# Zen Wind Farm and associated infrastructure, Western Cape Province

Motivation for amendment of Environmental Authorisation

DFFE Reference No.: 14/12/16/3/3/2/322

July 2023

**Figure 5.7:** Map of heritage resources identified during the field assessment relative to the amended facility layout/s.

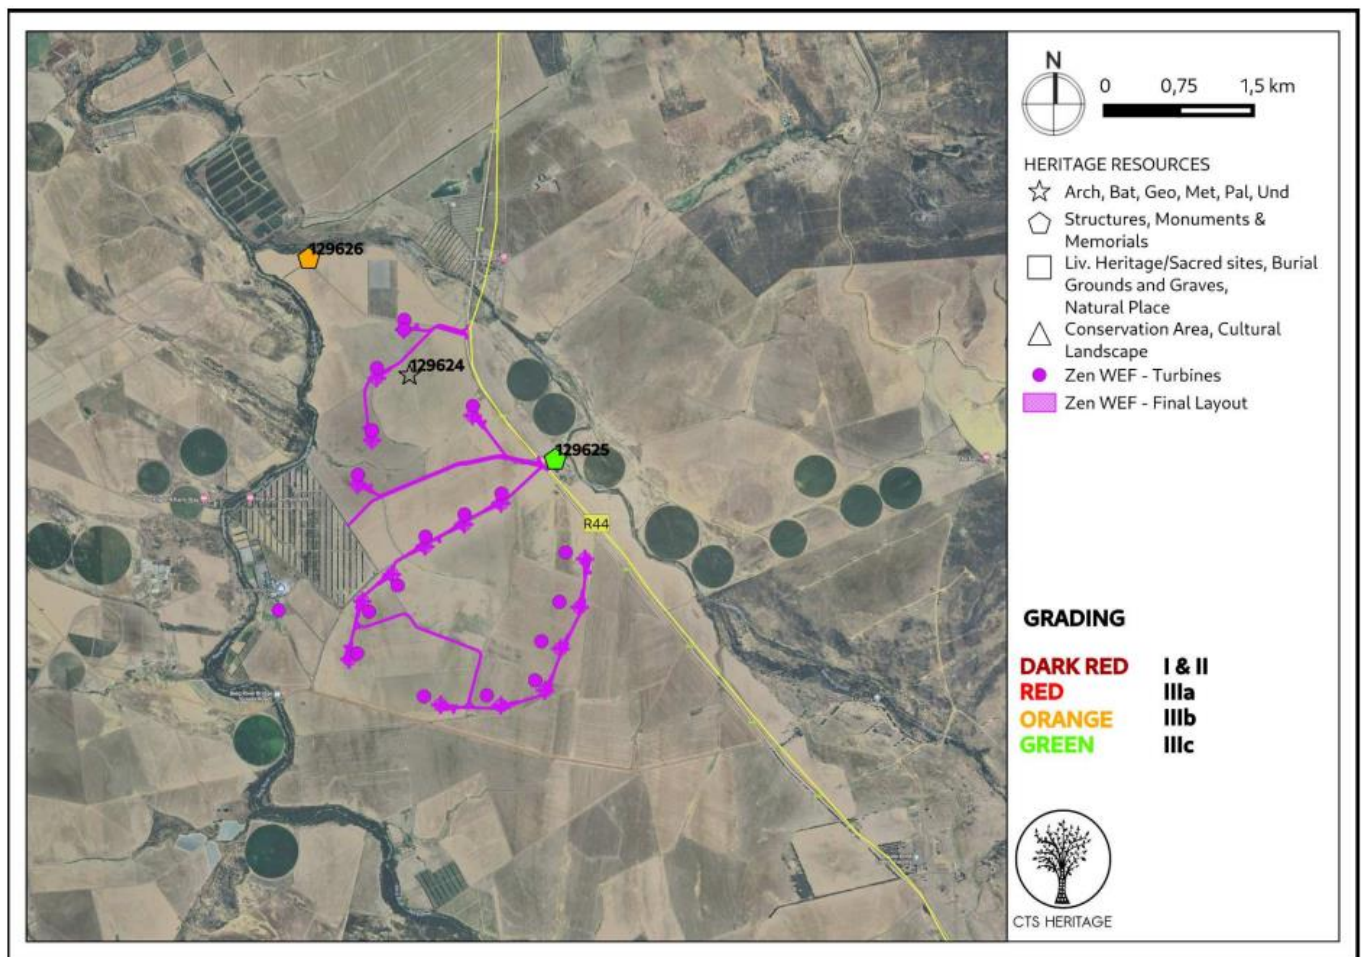
The amended facility layout for the Zen Wind Farm is considered an acceptable change from the perspective of the project's impact on the heritage and archaeological resources of the area. The original impact rating, which indicated low to moderate sensitivity for impacts on palaeontology and negligible impact on cultural heritage, remains valid. No additional mitigation and management measures are required to be included in the Environmental Management Programme (EMP) regarding heritage and archaeological resources impacts.
